153-157 Walker Street Response to DPHI and NS Council Comments

1. Response to DPHI Comments

Response to DPHI Comments

Eastern Elevation - Without 146 Arthur Street

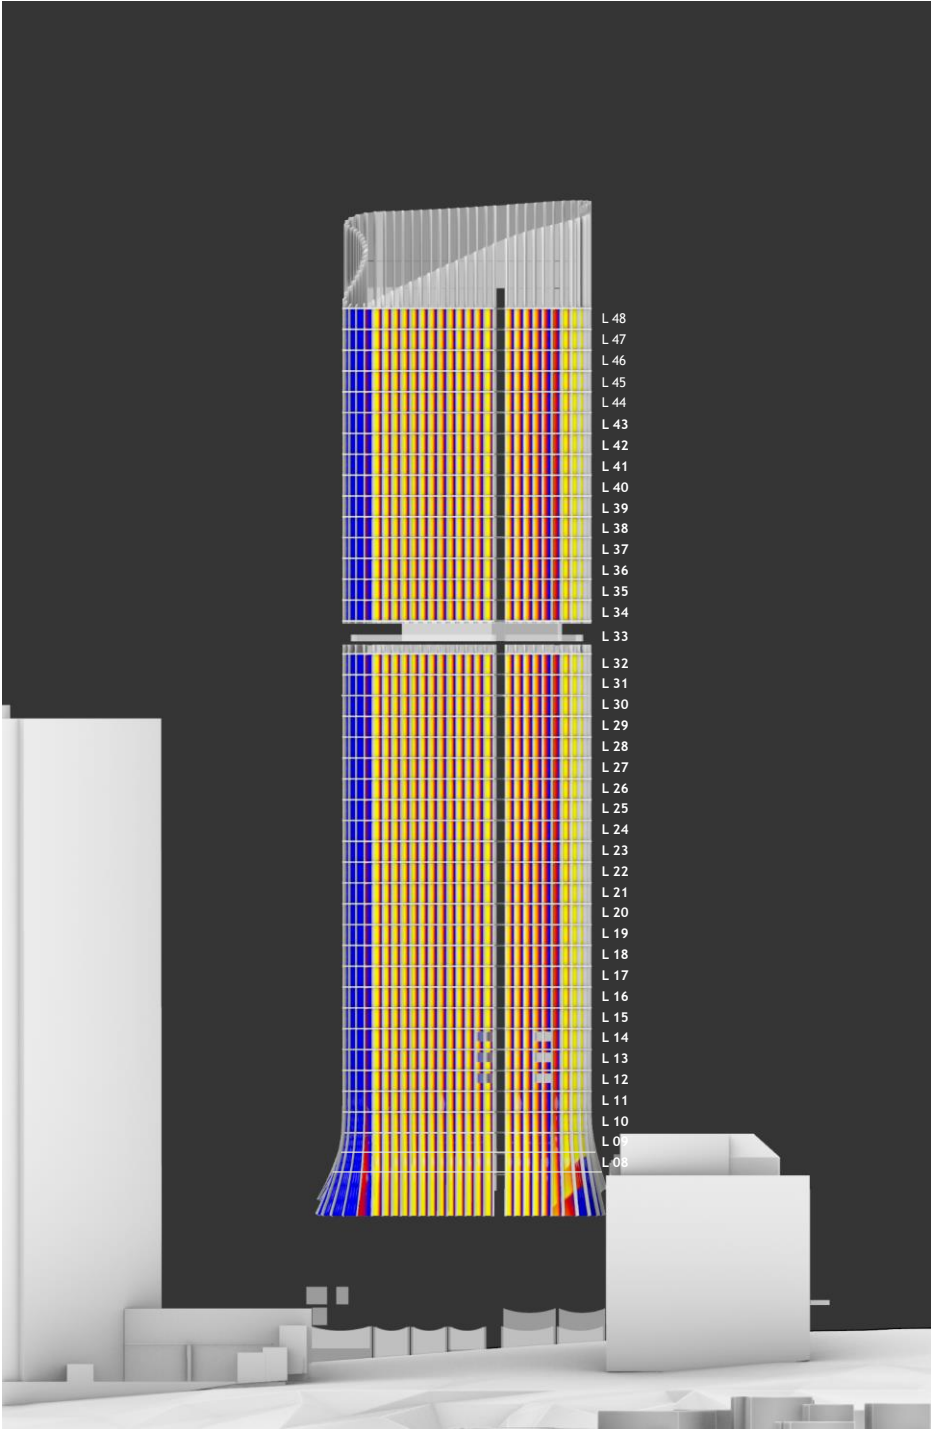
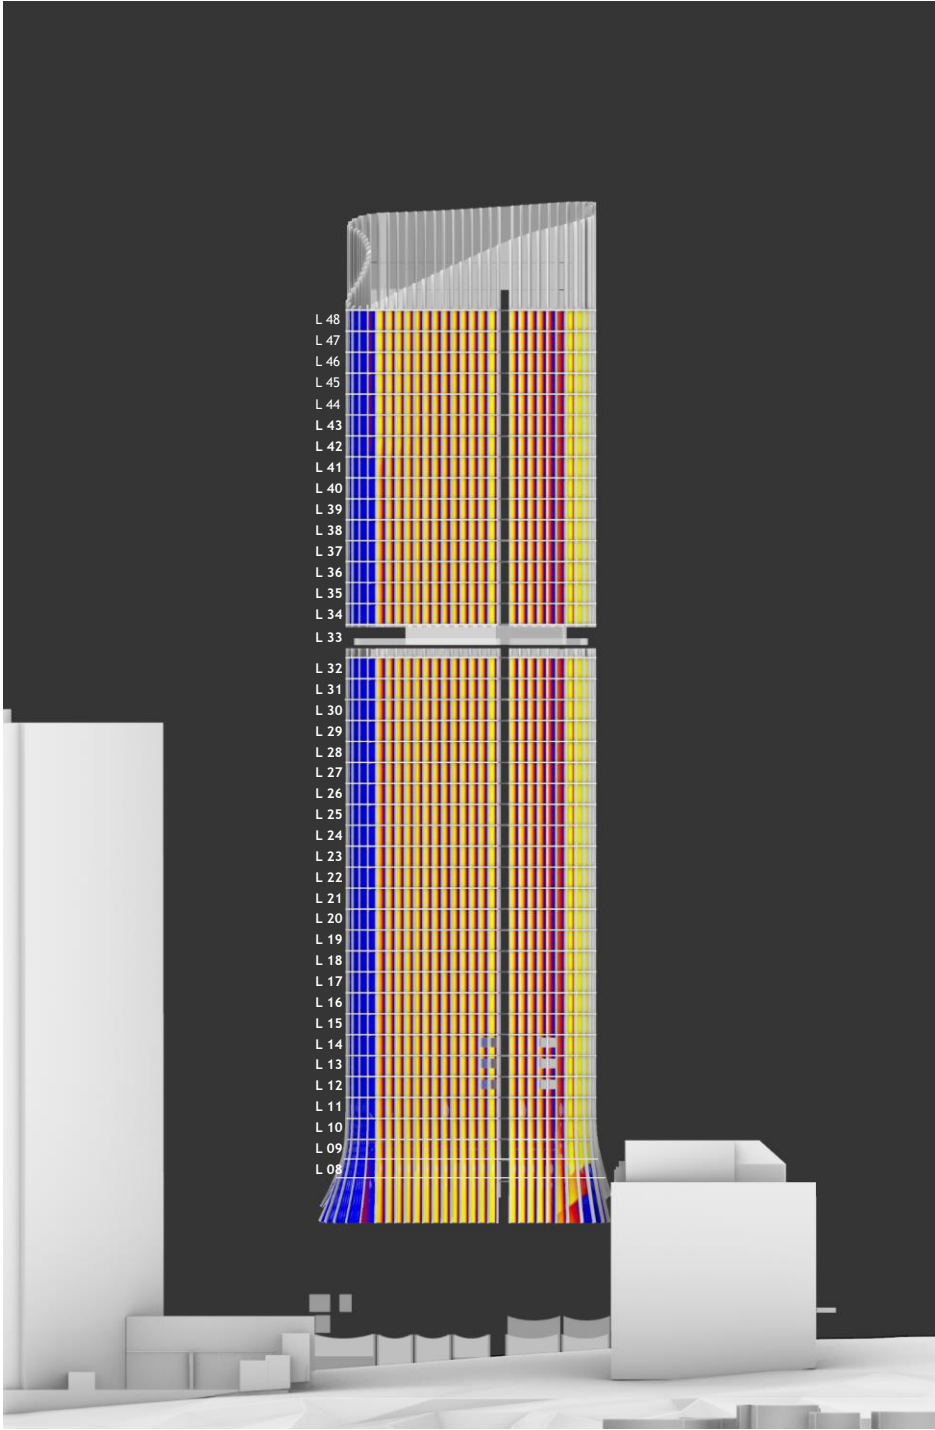
8. Further information is required to confirm the level of solar access to the dwellings of the proposal. Please provide hourly elevational solar diagrams and an accompanying information table in order to demonstrate where solar access falls within the building and its duration.

The images to the right illustrate an ADG Solar Access Analysis for the eastern elevation of the lodged design at 153-157 Walker Street. The ADG requires that at least 70% of apartments receive a minimum of two hours of direct sunlight on 21 June.

The analysis indicates that the approved 146 Arthur Street will have only a marginal, barely noticeable impact on the proposal's solar access as the images depict. The design continues to achieve compliance, maintaining solar access above the required 70% threshold (72% compliance).

Southern Elevation - Without 146 Arthur Street

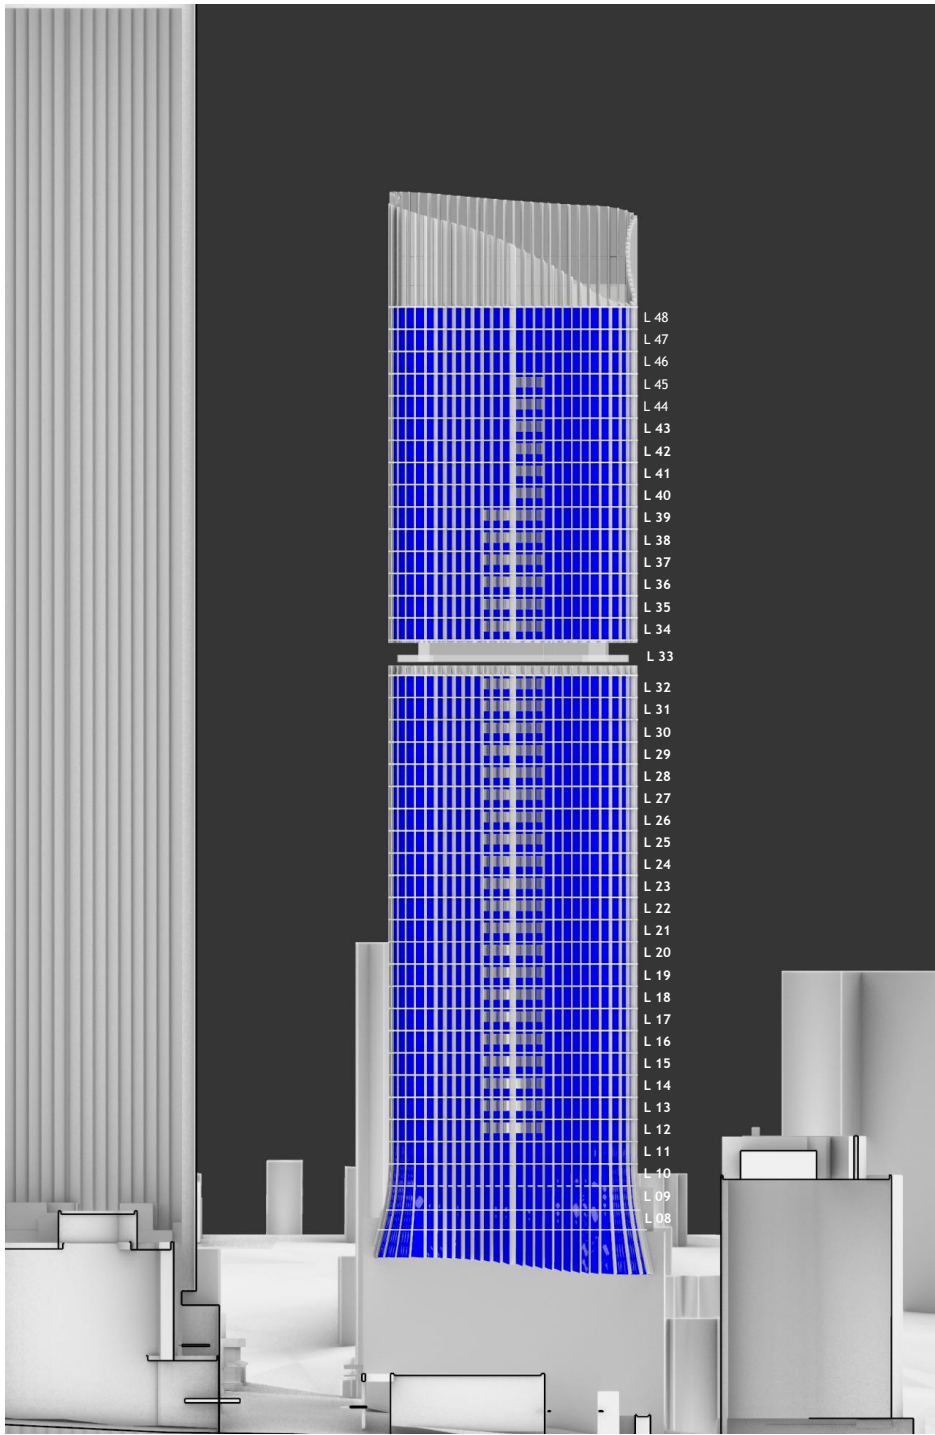
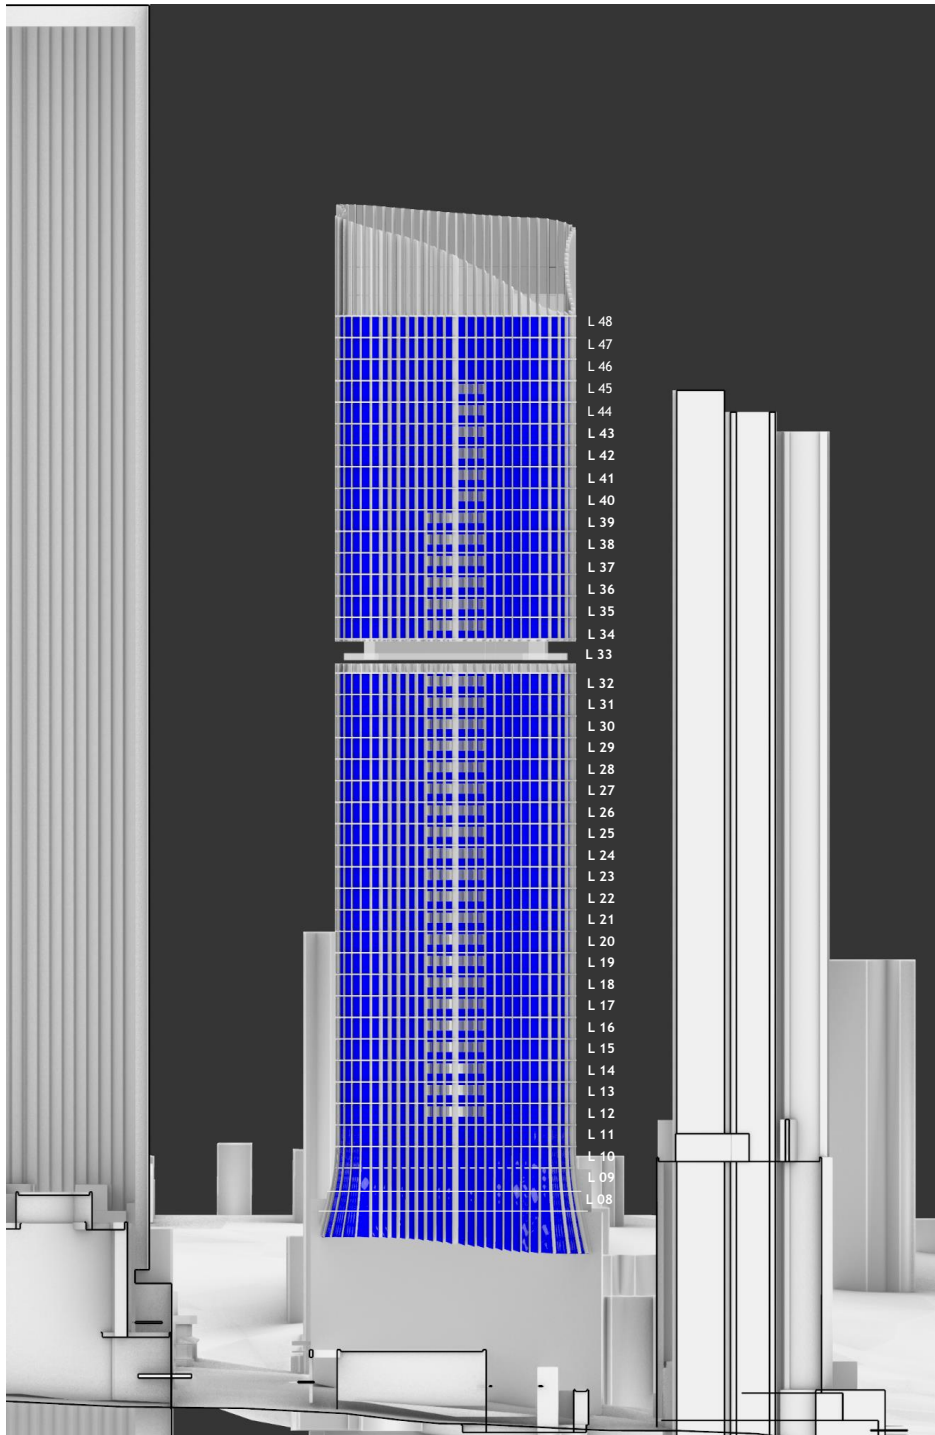
8. Further information is required to confirm the level of solar access to the dwellings of the proposal. Please provide hourly elevational solar diagrams and an accompanying information table in order to demonstrate where solar access falls within the building and its duration.

The images to the right illustrate an ADG Solar Access Analysis for the Southern elevation of the lodged design at 153-157 Walker Street. The ADG requires that at least 70% of apartments receive a minimum of two hours of direct sunlight on 21 June.

As the results depict, no apartment facing south receives 2 hr of direct sunlight due to its obvious orientation.

Overall the development achieves 72% ADG Solar Access compliance.

Level 08

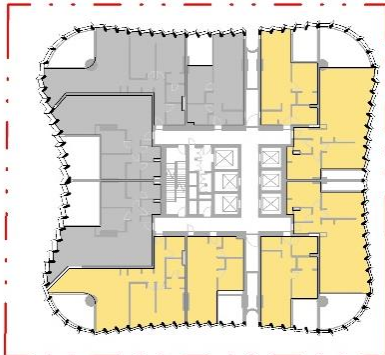
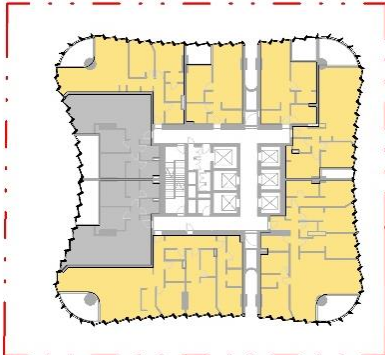
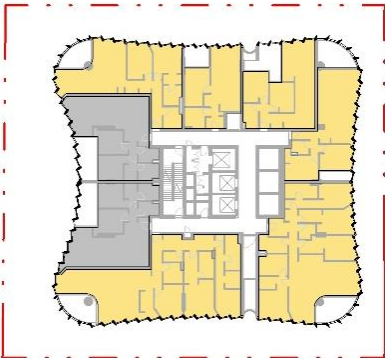
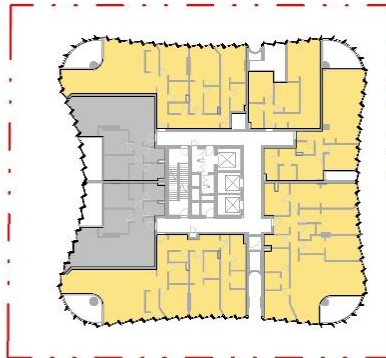
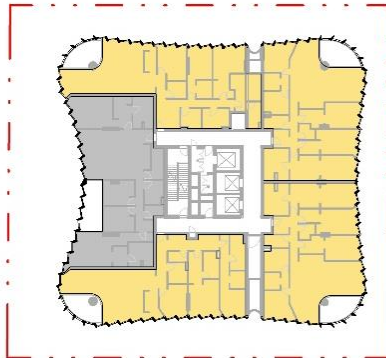
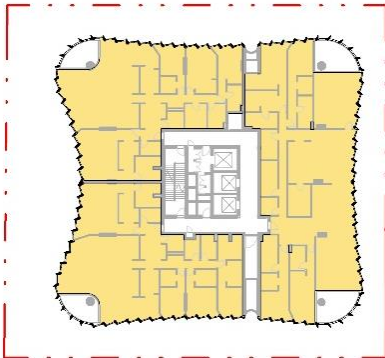
8. Further information is required to confirm the level of solar access to the dwellings of the proposal. Please provide hourly elevational solar diagrams and an accompanying information table in order to demonstrate where solar access falls within the building and its duration.

The plan diagrams to the right and the accompanying table confirm that the proposal achieves full compliance with the ADG solar access requirements.

Proposed Setbacks – Southern Setback (to 141 Walker Street)

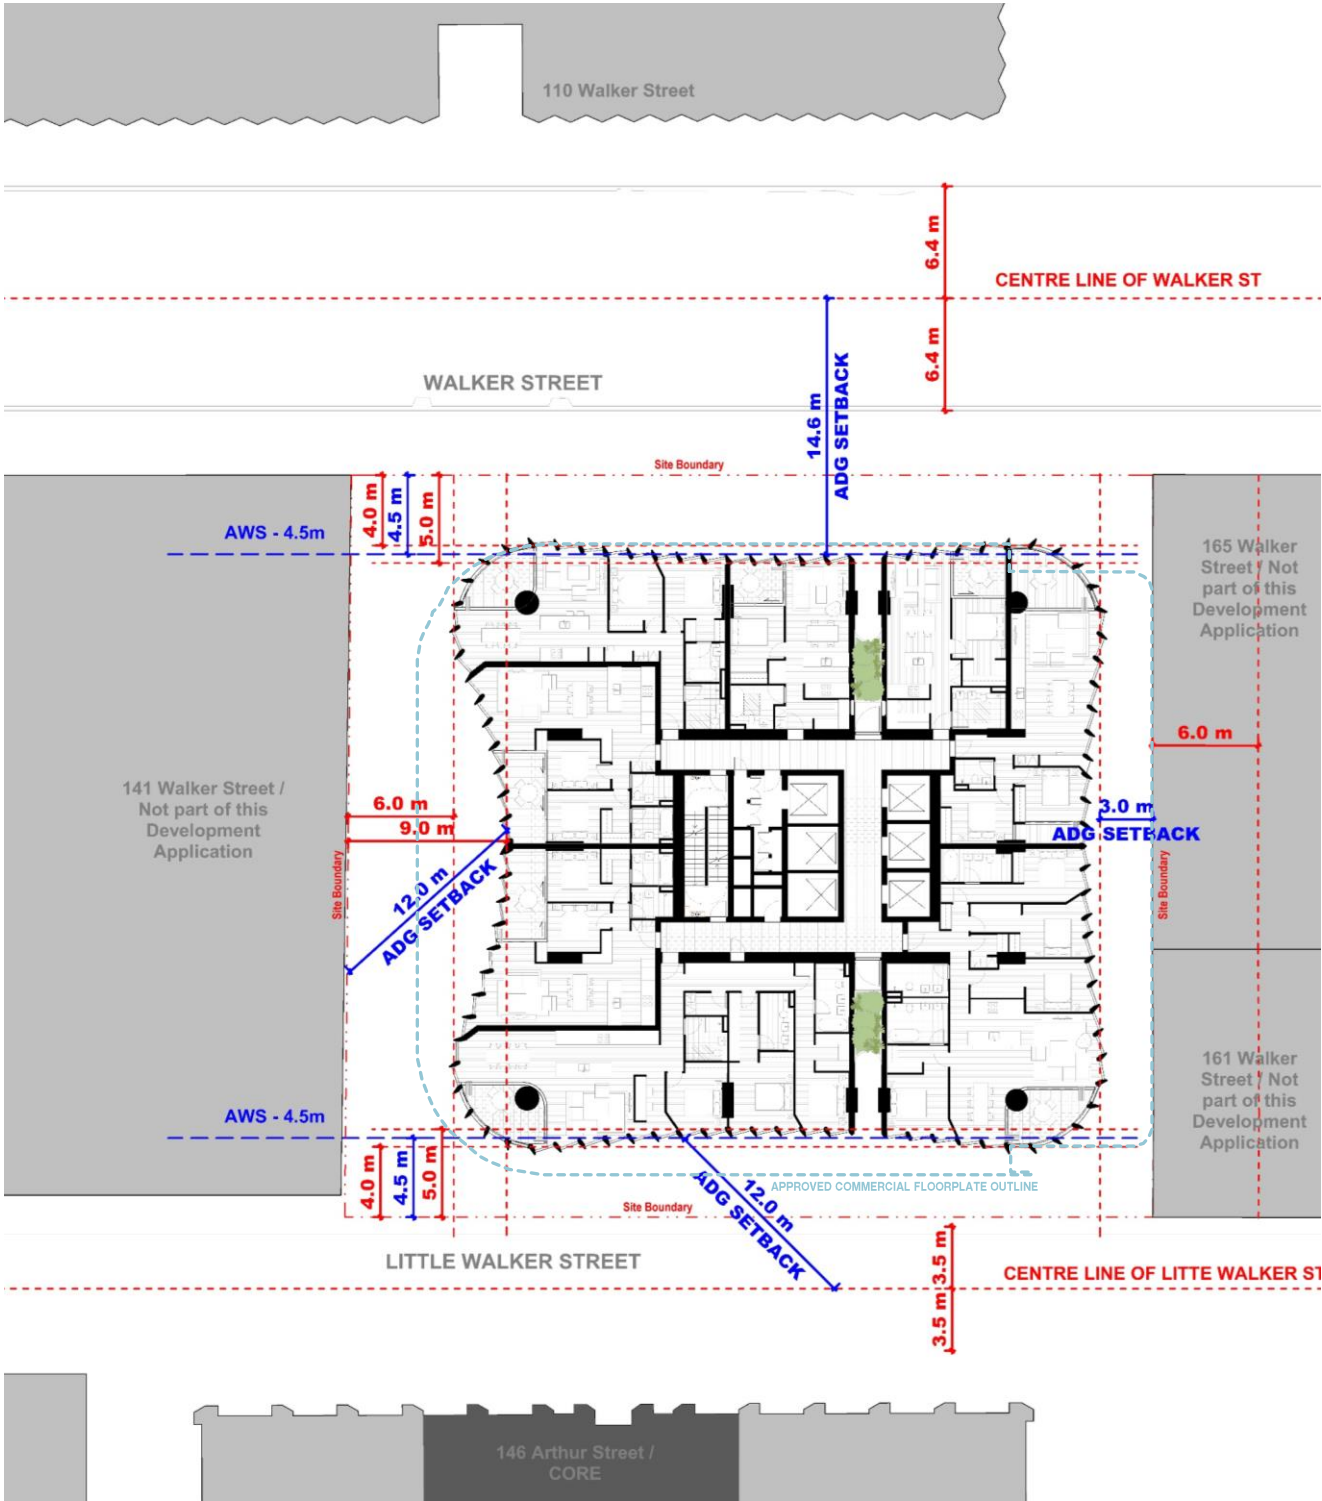
A. Building setbacks fall well short of Apartment Design Guide (ADG) minimums, leading to overshadowing, privacy loss, reduced daylight, and negative impacts on neighbouring commercial towers.

The Southern setback has been designed to achieve full compliance with the Apartment Design Guide (ADG) visual privacy provisions under Clause 3F-1, which requires a minimum 12 metre contribution from both sites (24m) for buildings above 25 m in height, measured from the primary habitable facade to the site boundary.

The proposal provides physical setbacks from the site boundary from 9m to 6m when measured from closest most projecting elements of the facade. However, when assessed according to the ADG methodology – measuring separation perpendicularly from the glazing line of habitable spaces – the southern setback achieves 12m as clearly illustrated in the accompanying diagram (referencing the ADG Setback line). The louvre location and façade angles assure the appearance of the façade as non-habitable (solid) when viewed directly from the neighbouring boundary (with ADG-compliant non-habitable setbacks) assuring appropriate visual privacy in accordance with the ADG requirements.

To further strengthen privacy outcomes and mitigate any residual perception of bulk, the southern elevation incorporates a full-height vertical louvre system that reads externally as a solid façade. This architectural treatment effectively removes direct sightlines toward the southern neighbour and satisfies the ADG requirement for minimising inter-visibility between dwellings, robustly achieving the performance outcomes of ADG Clause 3F-1.
